**FINAL
NEGATIVE DECLARATION
AND
ENVIRONMENTAL ASSESSMENT**

**TILLMAN WATER RECLAMATION PLANT
FLOOD PROTECTION PROJECT**

**CITY OF LOS ANGELES
DEPARTMENT OF PUBLIC WORKS
Bureau of Engineering
ROBERT S. HORII
City Engineer**

JUNE 1991

FIGURE 2
EA-8

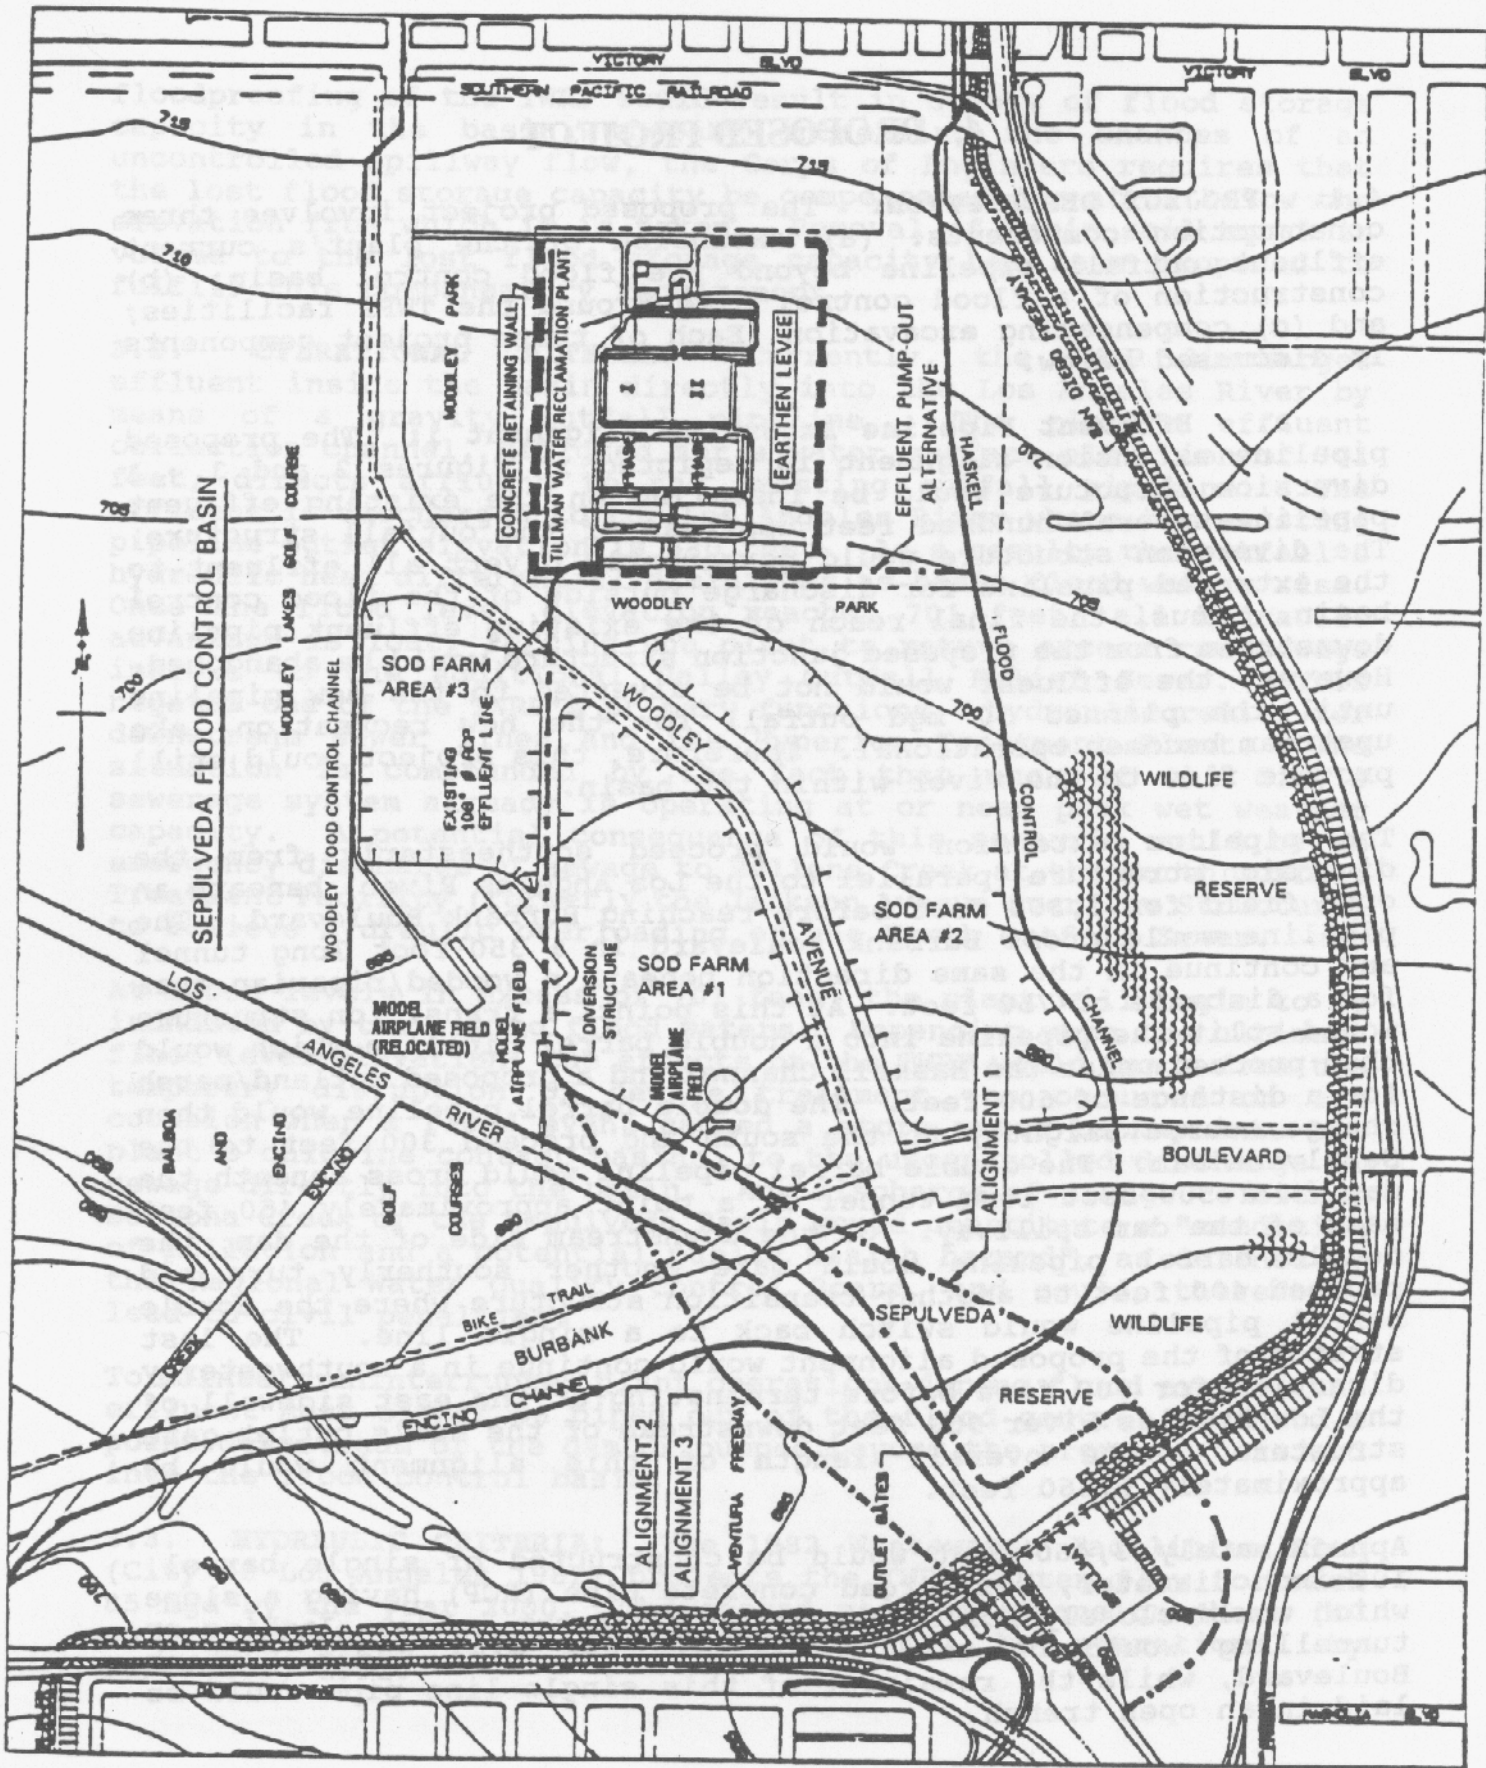
- a. Are there any proposed or approved plans for expansion of the TWRP beyond the boundary of the proposed Flood Control Dike?
- b. If there are such proposed or approved plans for such expansion, what areas would be used for compensating excavation?
- c. Would such compensating excavation take place in the north Wildlife Reserve?
- d. On page EA-8, Figure 2, there is a dashed line (one long, two short pattern) around the TWRP. What does this dashed line signify?

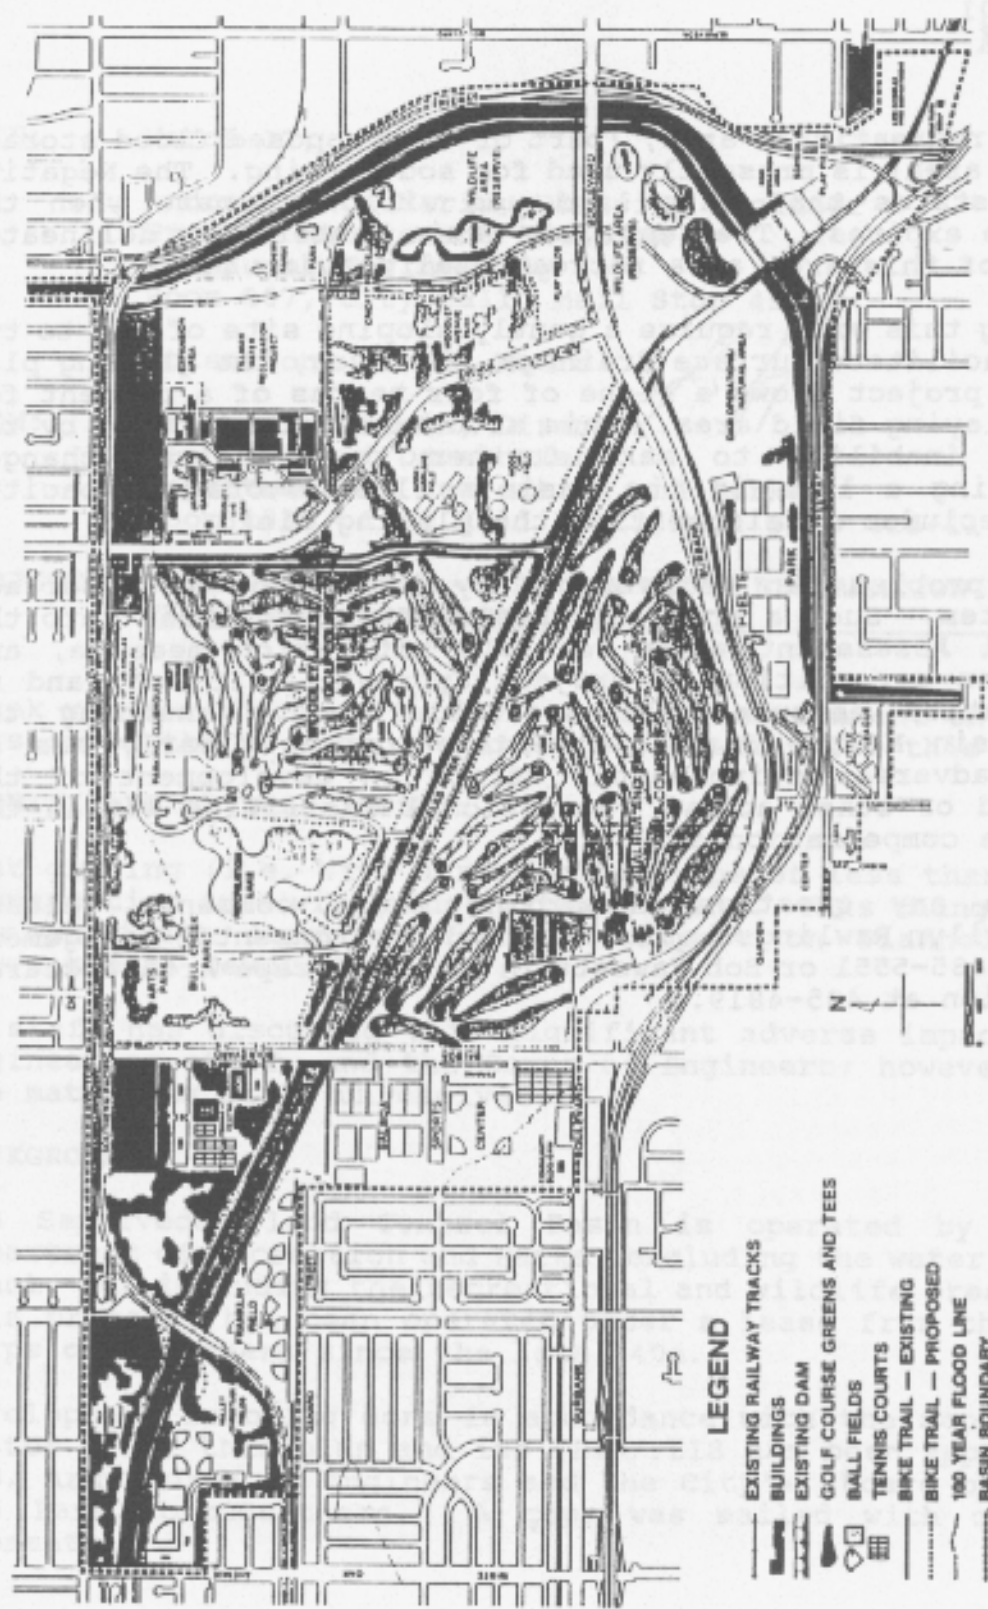
The proposed recreational area, (part of the proposed flood storage compensation area) is presently used for sod farming. The Negative Declaration states that this land use will terminate when the current lease expires. The Sepulveda Basin Master Plan delineates development of this area as a recreational playing field.

Accomplishing this will require a gently sloping site of one to two percent to facilitate surface drainage. However, the grading plan for the TWRP project shows a slope of four tenths of a percent for the future playing field area. This situation, complicated by the Department's inability to make further topographical changes without causing a loss in the basin's flood storage capacity, virtually precludes development of the playing field.

The grading problem can be overcome by installing a subsurface drainage system. Such a proposal should be incorporated into the Environmental Assessment as a feasible mitigation measure, and implemented as a condition of project approval. If not, and no other mitigation measures are available (e.g., amending the Sepulveda Basin Master Plan), then the project clearly has an unavoidable adverse environmental effect on development of the playing field or other active recreational facilities within the flood storage compensation area.
